Nº 131 SERVICE BULLETIN

SUBJ: Electric Company Sign / Backbox J2 Harness Re-dress

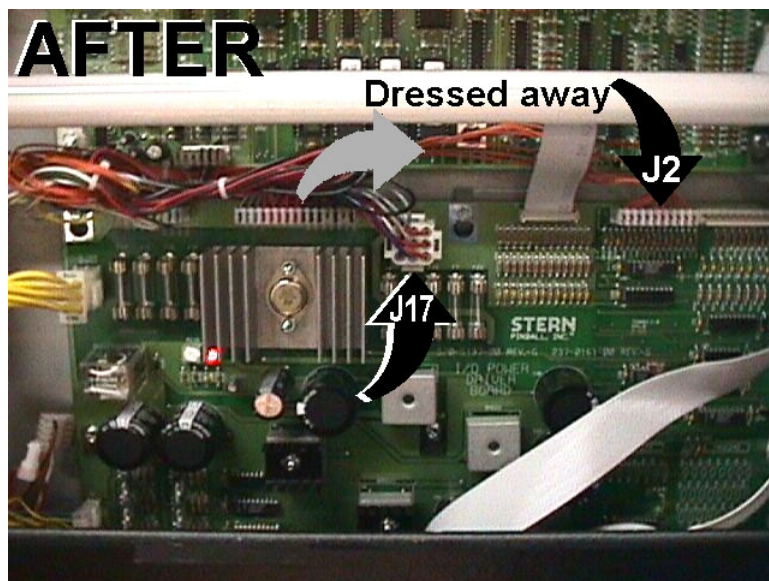
The **J2 Harness** that carries the data from the I/O Bd. to the Electric Co. Sign has been dressed in such a way that it is picking up electrical noise/surges from the **J17 A.C. Harness**. This harness is used to supply the A.C. voltages to the I/O Board from the secondary of the transformer. See the "**BEFORE**" picture of the I/O Board which shows the **J2 Harness** wrapped around the **J17 Harness**. If left alone (wires wrapped around J17 harness), it could cause damage to the I/O Board or the Electric Company Sign.

I.C.'s **U201** and/or **U206** have failed on the I/O Power Driver Board.

Re-dress **J2 Harness** (I/O Bd. Aux. Out) away from the **J17 Harness** (I/O Bd. Transformer). See the "**AFTER**" picture of the I/O Board which shows the **J2 Harness** re-dressed & separated from the **J17 Harness**.
